Front Service Washer Updates

GE Appliances

HOME LAUNDRY HL3-96
LOUISVILLE BUILT "T" MODEL-
HOTPOINT, GE, RCA WASHERS.
LOWER HARNESS KIT

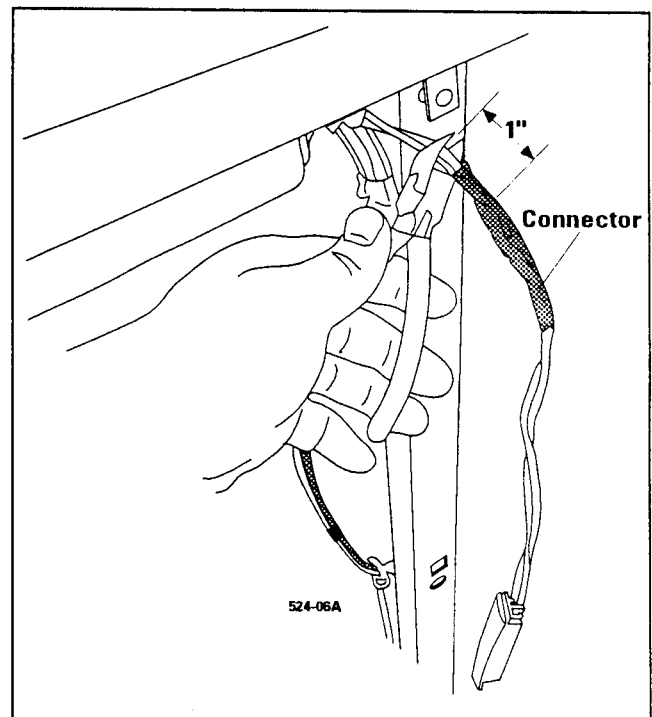
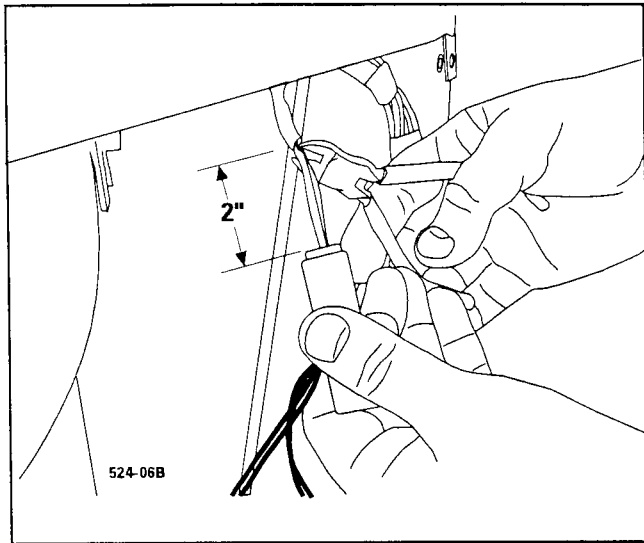
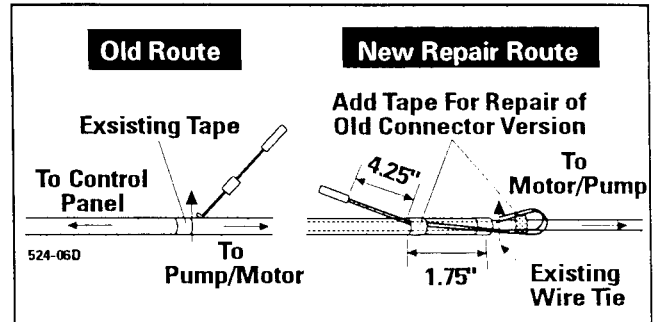
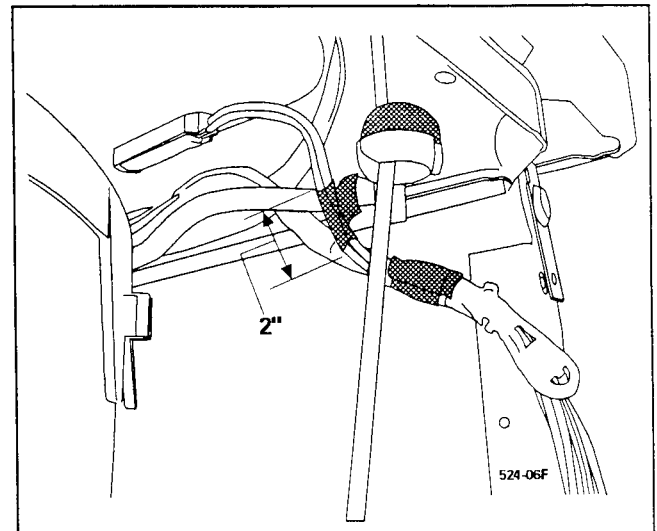
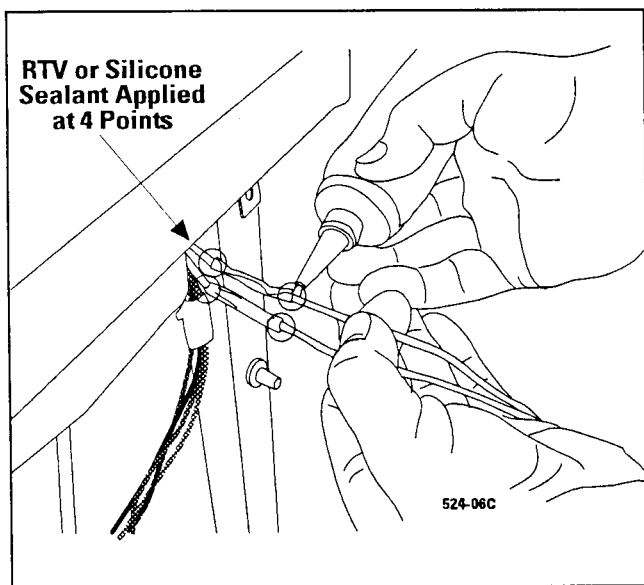
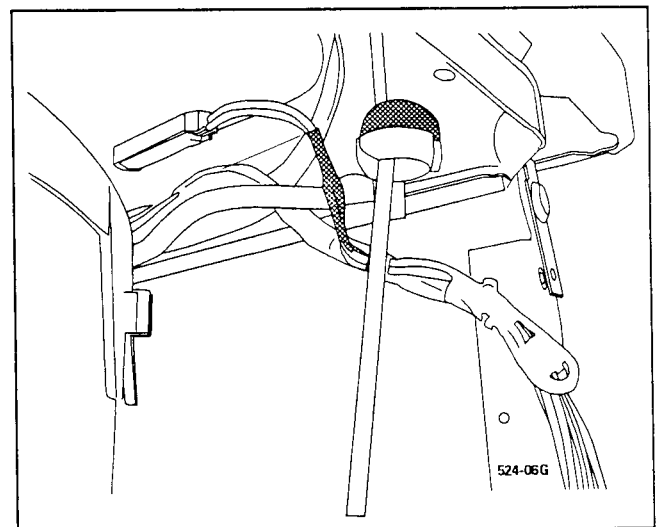
Effective June 2000, all washer reed switch harnesses will include a **new wiring route** to the reed lid switch. This is necessary to avoid interference of lid switch wiring with the tubcover alignment tabs.

1. If lid switch has plastic connector (old version) cut wire leads 1" from connector on harness side.

- If lid switch does not have plastic connector (new version), cut both lid switch wire leads 2" from switch.

- Route the replaced switch per the repair shown below. Route the switch in this way regardless of version used.

- Wrap lid switch wires with black electrical tape. Tape should be at least 2" as shown in illustration below.

- Strip 3/16" on both 18 gauge harness wires.
- If original switch did not have a connector, cut the new 9" switch wire leads at 2" from the new switch housing. Otherwise, proceed to Step 5.
- Using the 18 gauge crimp tool, crimp each lid switch wire lead to a harness wire lead.
- Seal each side of both crimp connections with RTV or silicone sealant.
